# Road & Bridge Design Publications

Monthly Update – March 2023

Revisions for the month of **March** are listed and displayed below and will be included in projects submitted for the **July** letting.

GUARDRAIL  
MEDIAN OBJECT PROTECTION

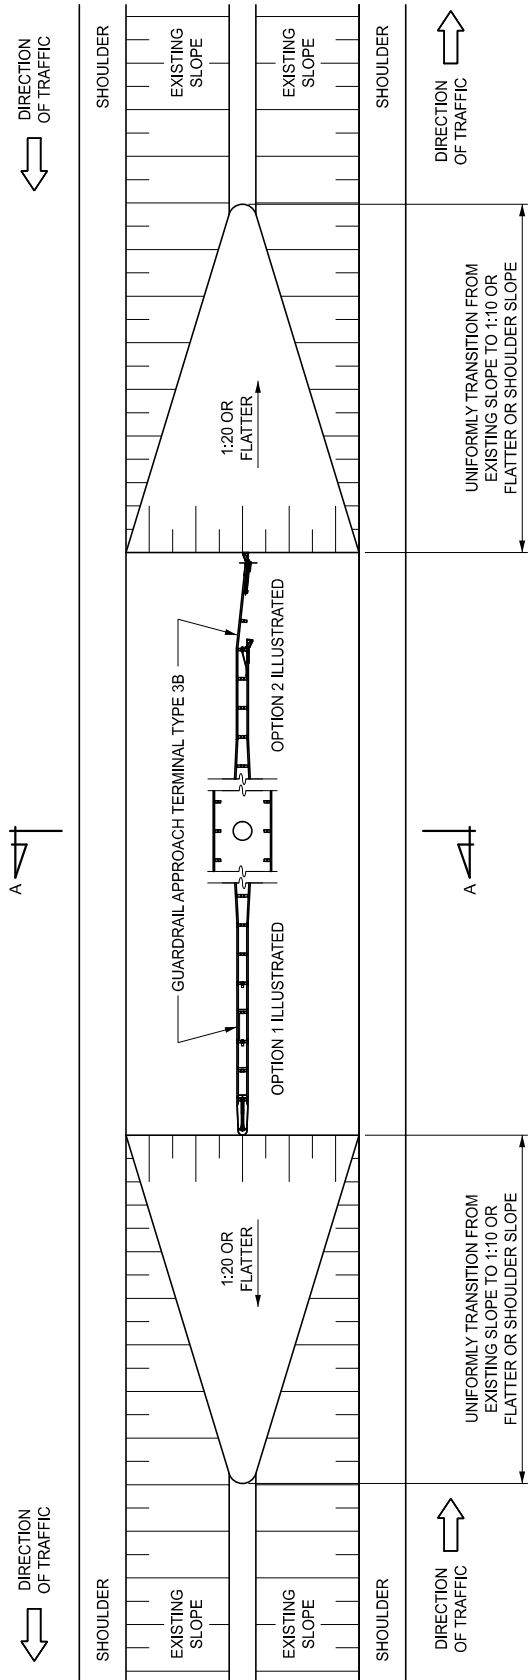
R-56-F: Guardrail Median Object Protection: On sheets one, four, and five, extended the length of the Guardrail Approach Terminal, Type 3B (Option 1) to include the 12'-6" of Type BD guardrail, which was previously shown separately but paid for as part of the terminal.

ELEVATION  
 GUARDRAIL APPROACH TERMINAL, TYPE 3B  
 "C-A-T"

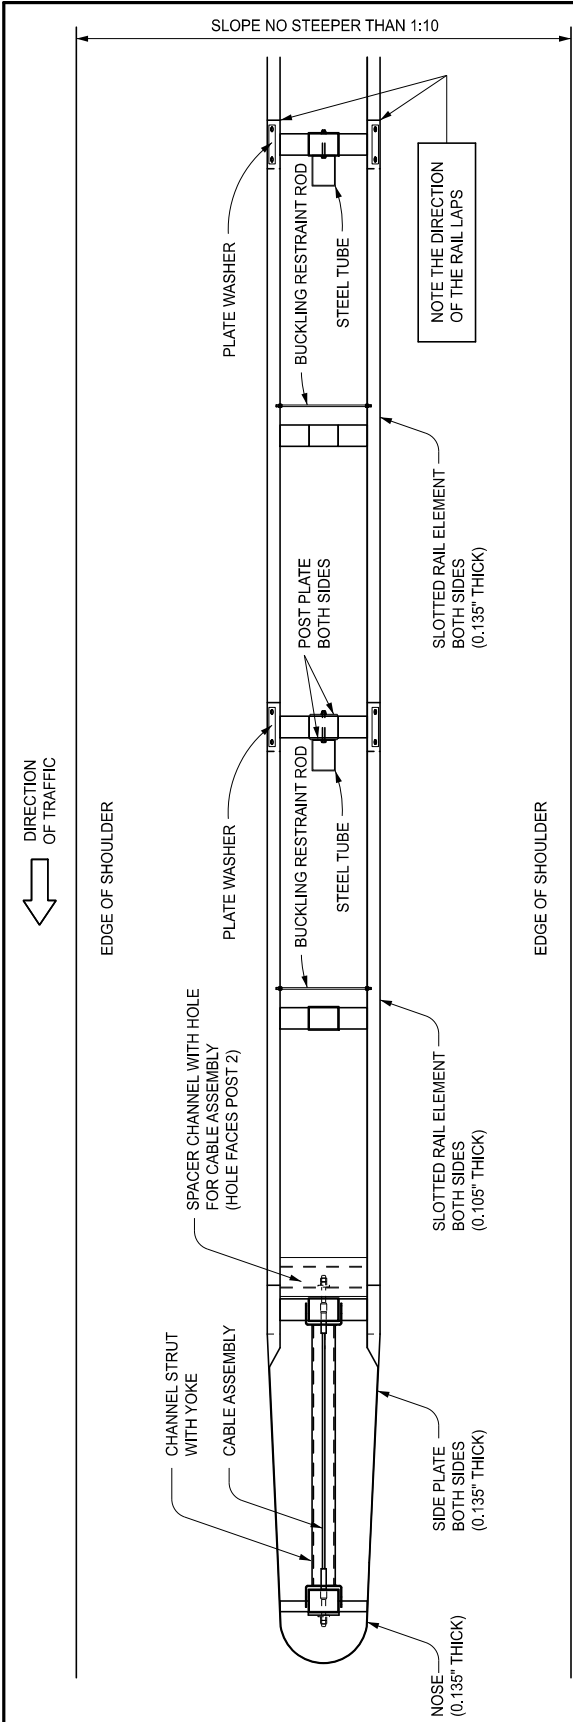
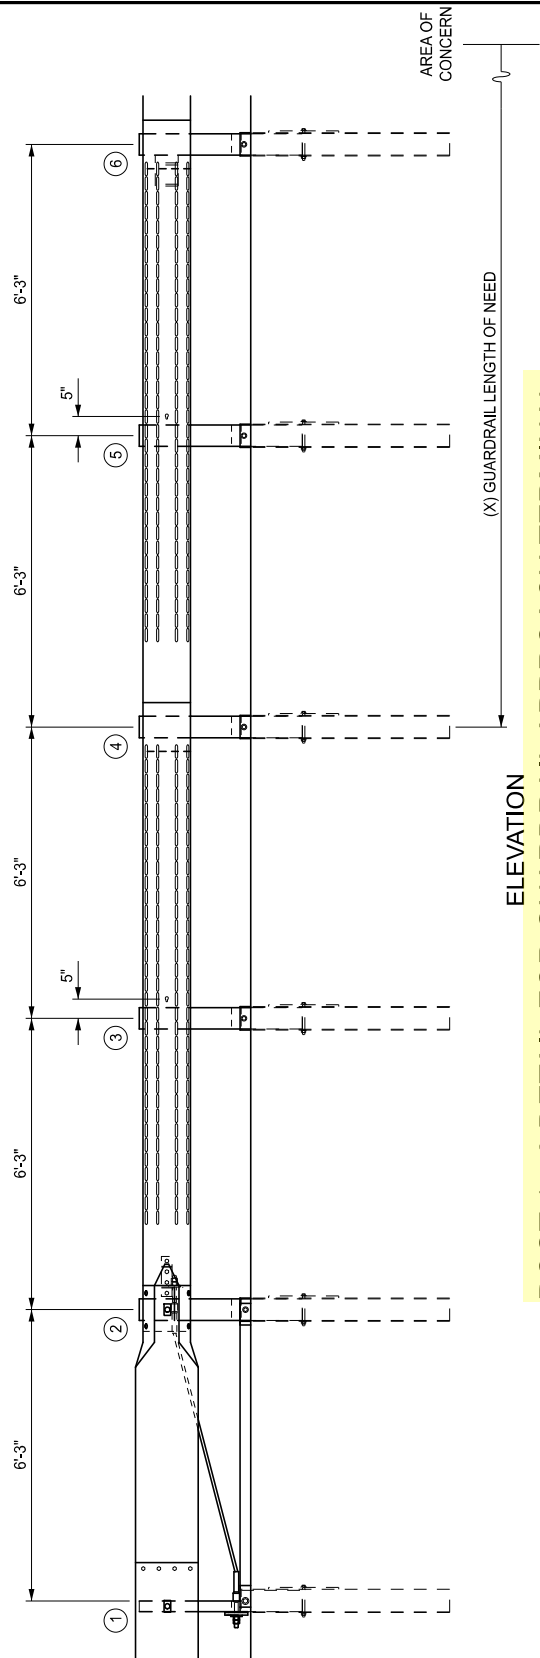
R-63-C: Guardrail Approach Terminal, Type 3B & 3T: Added a new sheet displaying the full length of the "C-A-T" terminal and the guardrail it ties into. (The length of the Guardrail Approach Terminal, Type 3B (Option 1) was extended to include the 12'-6" of Type BD guardrail which was previously shown separately but paid for as part of the terminal.) On sheets one and ten, added guardrail Types BD & MGS-8 to the types of guardrail the terminal ties into.

STEEL END SECTION FOR CORRUGATED STEEL CIRCULAR PIPE

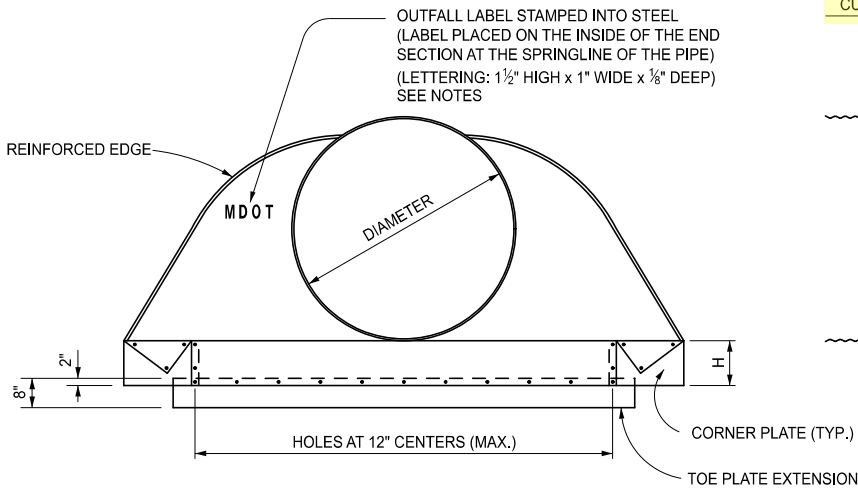
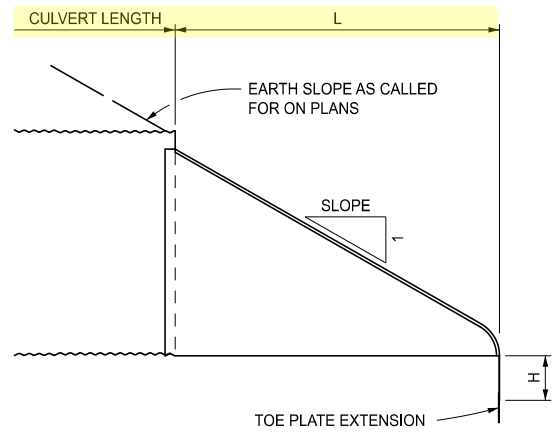
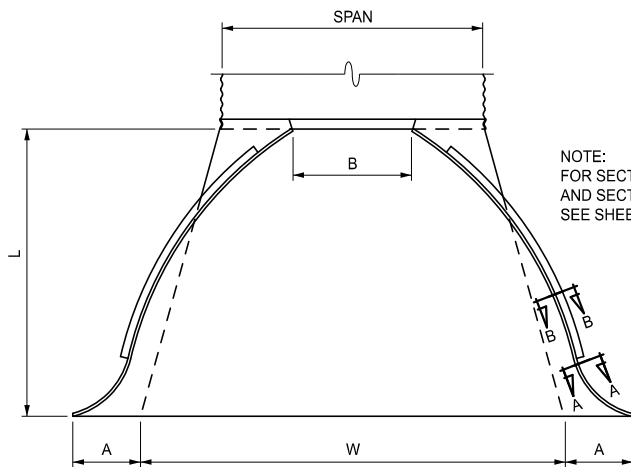
R-88-E: Steel End Section: Eliminated the "C" dimension (to match the 2020 Standard Specifications for Construction) as this length of culvert is no longer paid for in the cost of the steel end section.

BRIDGE RAILING, 2 TUBE

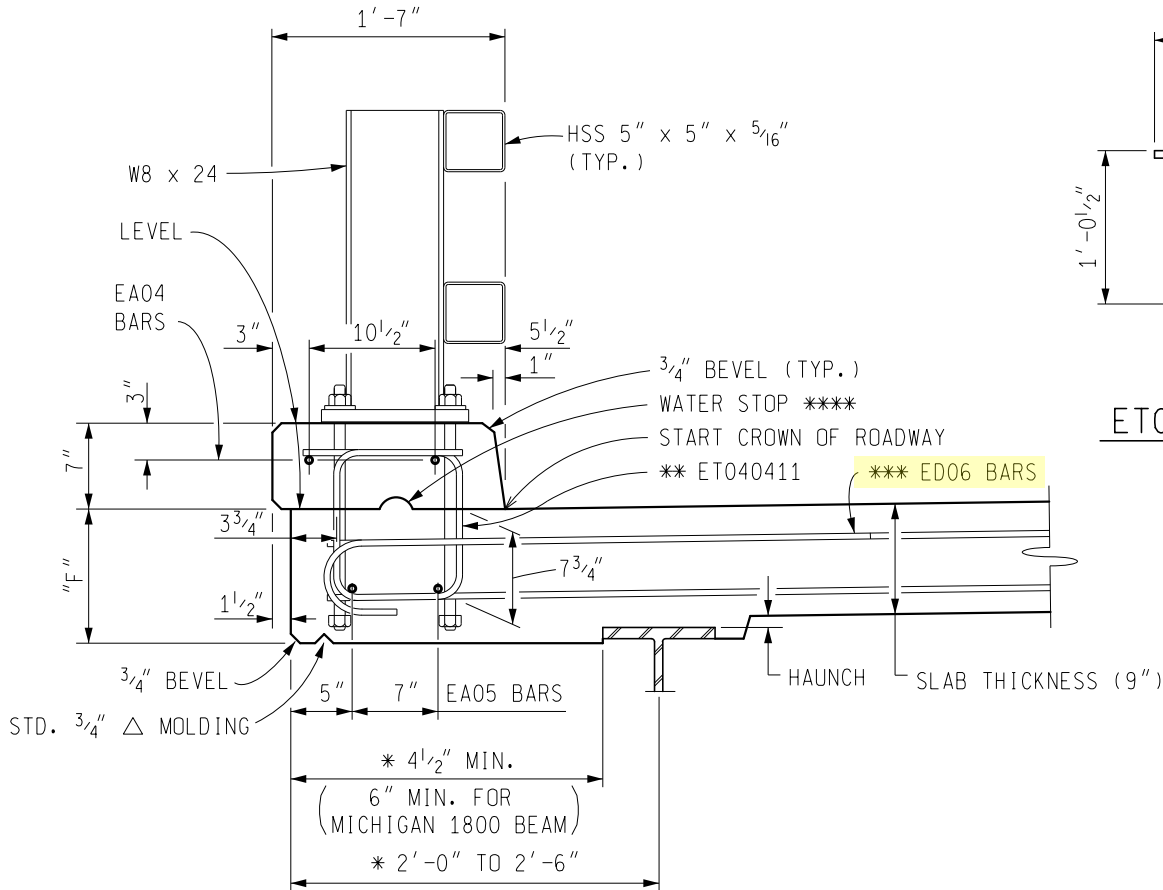
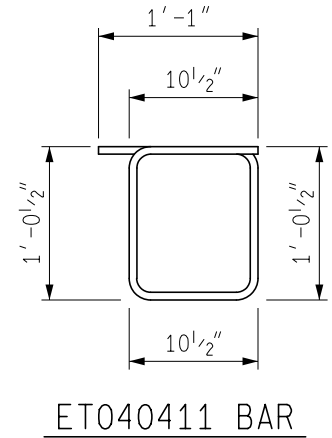
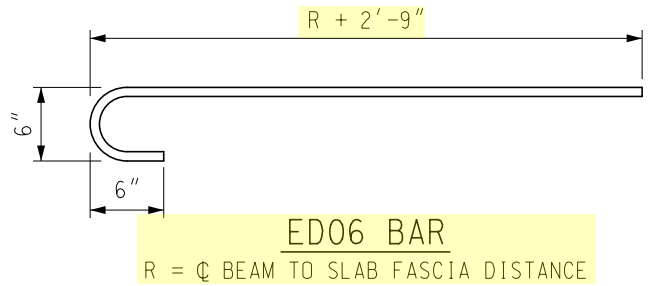
6.29.06, 6.29.10, 6.29.10C, 6.29.17, 6.29.17E: Provided clarification that slab overhangs must be designed on all projects regardless of the overhang width. Any slab reinforcement shown on the Bridge Design Guides is the minimum reinforcement required, and if the design requires larger or additional reinforcement it must be included in the plan details.

THE DETAILED REINFORCEMENT IN THE SLAB (EA05 & ED06 BARS) IS THE MINIMUM FOR THE RAILING. THE DESIGN OF THE SLAB OVERHANG MAY REQUIRE ADDITIONAL REINFORCEMENT (OR INCREASING THE REINFORCEMENT AREA (DIAMETER) SHOWN). BARS WITH PREFIX "E" ARE TO BE EPOXY COATED.
